memorandum

date March 18, 2019
to Vera Kolias, AICP
from Sarah Hartung, Senior Biologist
subject Natural Resource Review for Elk Rock Estates

Photo 1: Looking west at the subject property which includes an open field with grasses and forbs as well as debris piles. A handful of black cottonwood trees are growing along the western boundary – although it’s not clear if these should be included on the site plans. March 16, 2019.

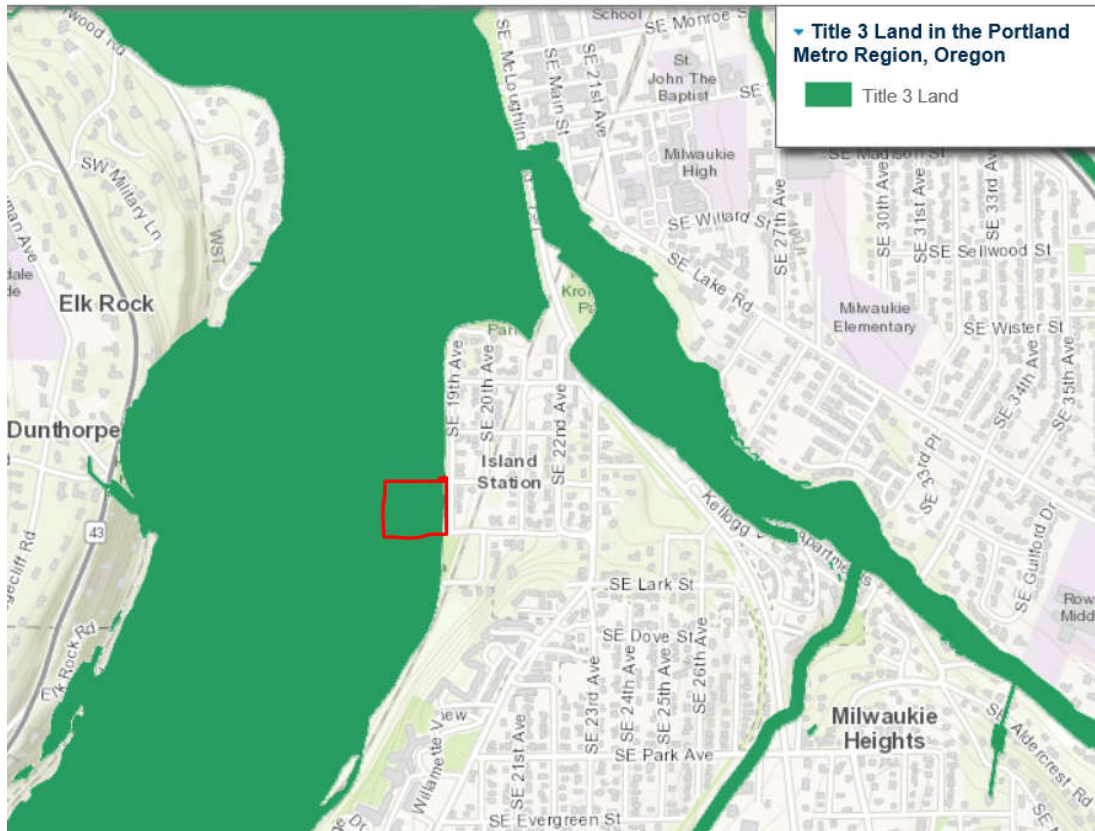
Response: The inventory of existing vegetation looks reasonably accurate, although it's not clear if more black cottonwood trees should be shown on the map within the subject properties. Only 2 trees are mapped at the northwest end on the landscaping plan Sheet L1. The application concludes that the study area is "degraded" based on the low cover of shrubs and trees and the high percentage of weeds in the groundcover. This characterization is assumed to meet the Class C "Poor" category per Table 19. 402.11.C. The application does not provide a detailed discussion of ecological functions of riparian habitat.

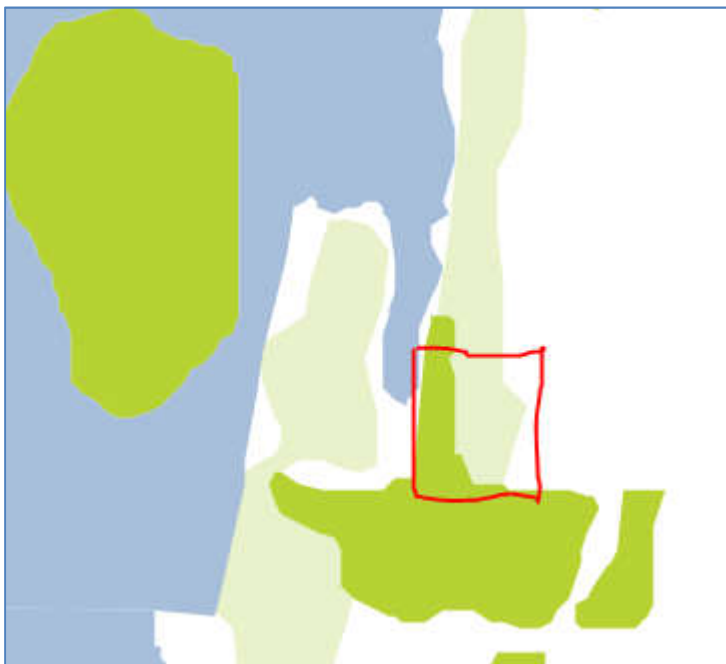
The application states that Wetlands A and B are secondary protected features, but then correctly identifies a 50-foot buffer that overlaps with the study area. The off-site wetlands (A and B) are primary protected features with 50-foot buffers because they occur within Title 3 Land as mapped by Metro – see snippet below. The project site is approximated in red – west of SE 19th Ave and within Metro’s Title 3 Lands: <https://databasin.org/maps/new#datasets=88691cc47cbd4992838864c29dbb147f>
